PURPOSE: To announce clearance updates to Rinnai twin pipe venting systems.

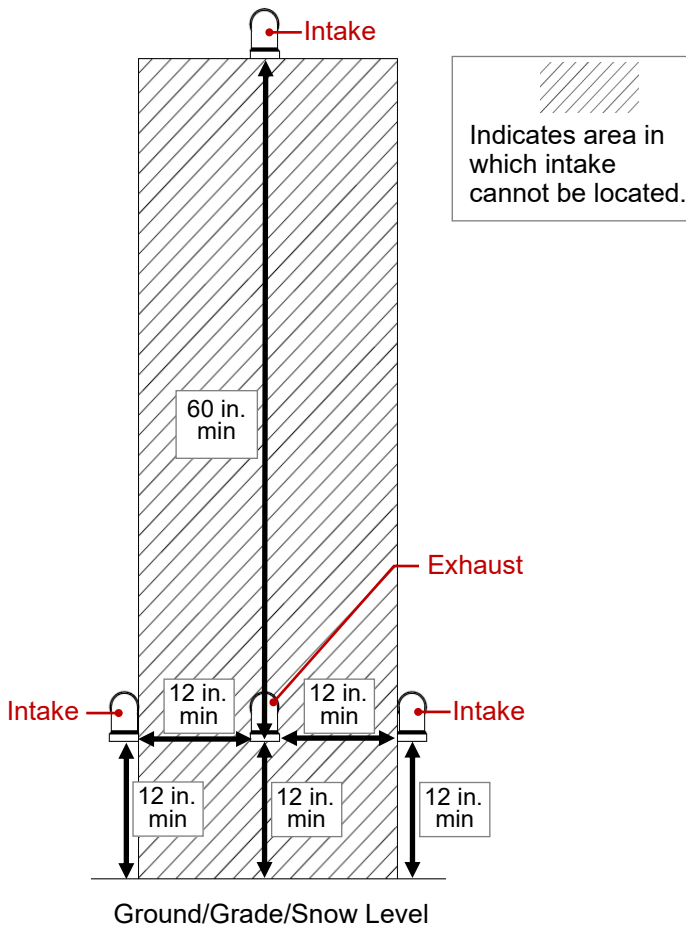
This clearance update applies only to twin pipe venting systems that are not utilizing a third-party manufactured and Rinnai-approved vent termination, such as low profile or wall termination kits (examples shown below).

Required termination clearances for twin pipe (also known as two pipe or dual pipe) venting systems have been updated to minimum 12 in. (30 cm). Technical literature will be updated to reflect the new clearances.
